SERVICE BULLETIN

SB97.6

Outrigger Component Replacement
Machines/Models: LX - Domestic

PURPOSE: Replace the existing outrigger cylinder pads and retaining bolts.

Figure 1

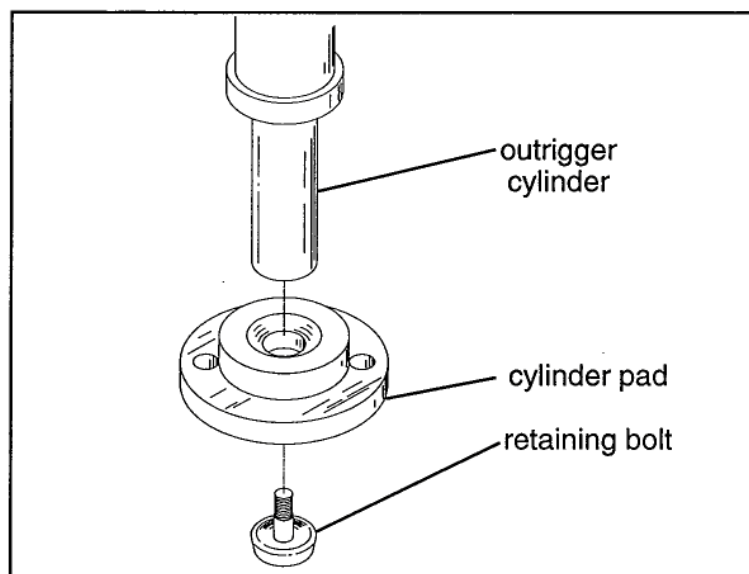
OPERATION REQUIRED: Replacement of all outrigger cylinder pads and retaining bolts per instructions below. This operation is to be completed at the next regular service interval.

1. Ensure that the outrigger is completely retracted before installation of new cylinder pad and retaining bolt.
2. Remove existing cylinder pad and retaining bolt and discard.
3. Apply medium strength thread lock to retaining bolt. Install outrigger cylinder pad and retaining bolt to outrigger cylinder. (Figure 1)
4. Using a 1 1/2" spanner wrench, torque retaining bolt to 20 ft. lbs.

Domestic Models: 4 ea. 67840-011 Pad, 6° with retaining bolt.
